# COUNCIL ASSESSMENT REPORT

| <b>Panel Reference</b>                    | PPSSCC-404   |
| <b>DA Number</b>                          | DA/904/2022<br>PAN-276050  |
| <b>Proposed Development</b>               | Construction of a residential flat building complex (Block C) comprising 4 x buildings ranging in height between 7 storeys and 20 storeys containing a total of 300 dwellings, 445 car parking spaces and associated landscaping. The proposal is Nominated Integrated Development as approval is required under the Water Management Act 2000.  |

Level 03 Podium Landscaping

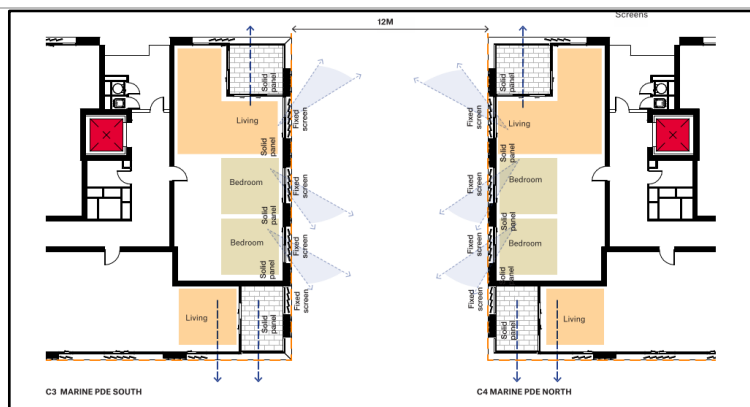
| PARAMETER   | DESIGN CRITERIA   | PROPOSAL   | COMPLIANCE |
|---|---|--|------------|
| <b>Discussion of Non-Compliance</b><br>Deep soil calculated in accordance with the ADG is not provided on site. It is noted that the provision of deep soil was not practically provided for within the Homebush Bay DCP or within the concept plan approval, particularly when considering the perimeter block design, street setbacks of 5m and less, and the recognition that car parking would be provided within aboveground podiums. There are deep soil pocket areas throughout the site (approximately 473m <sup>2</sup> ) however they do not achieve the 6m minimum widths. The ADG acknowledges that the design criteria may not be possible on some sites and advocates alternate forms of planting (such as on structure). In this regard, the proposal provides for a large communal open space on the podium level with planters up to 1.5m in depth and capable of supporting trees to a mature height of between 7-20m in addition to a range of shrubs, ferns/cycads, groundcovers and grasses. The ground level and Level 17 also contain a variety of plantings. The non-compliance with the numerical control is therefore considered acceptable in this circumstance. |   |  |            |

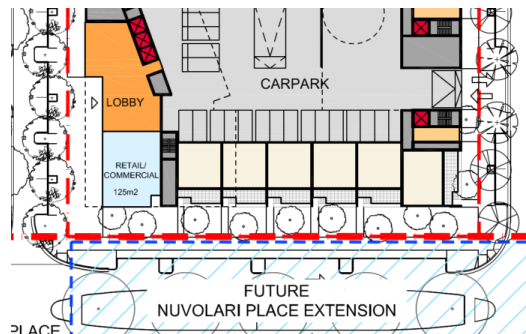
| Description of Change   | Details of Change   |
|---|---|
| <p>The 6 storey northern wing has been reduced to 2 storeys with floor area redistributed to the 7 storey setback area along Marine Parade.</p> <p><i>To improve solar access to communal open space and western facade of Marine Parade buildings. Also better aligns with the Block D 8 storey street wall to the east.</i></p>   |   |

*This also provides two distinct building forms and improves building modulation.*

Concept vehicular entrance from Marine Parade

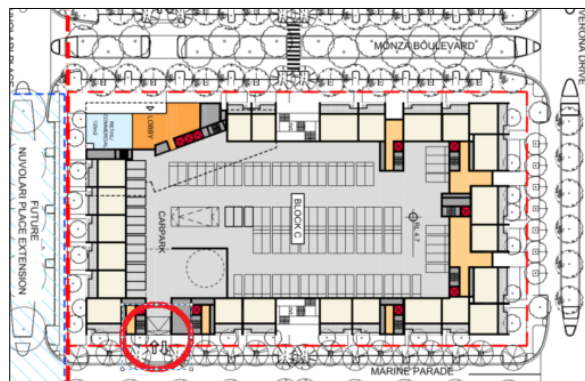
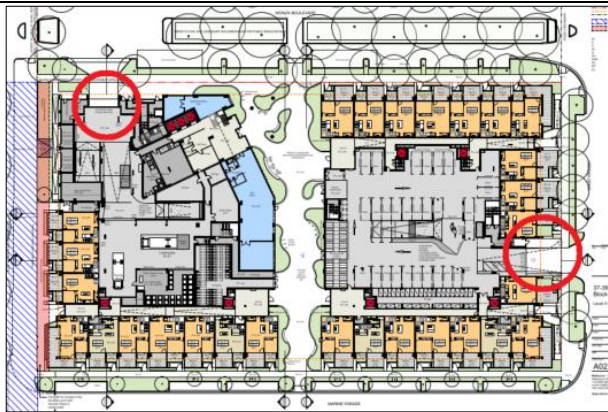
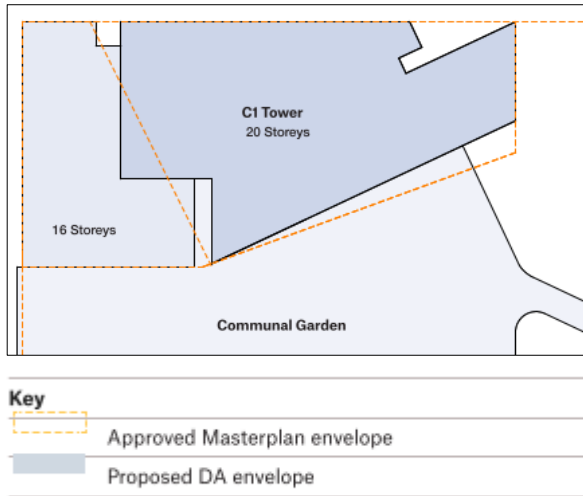
Vehicular entry removed from Marine Parade.

Vehicular entries now provided from Monza Blvde and Verona Drive to cater for access to the separated podia.
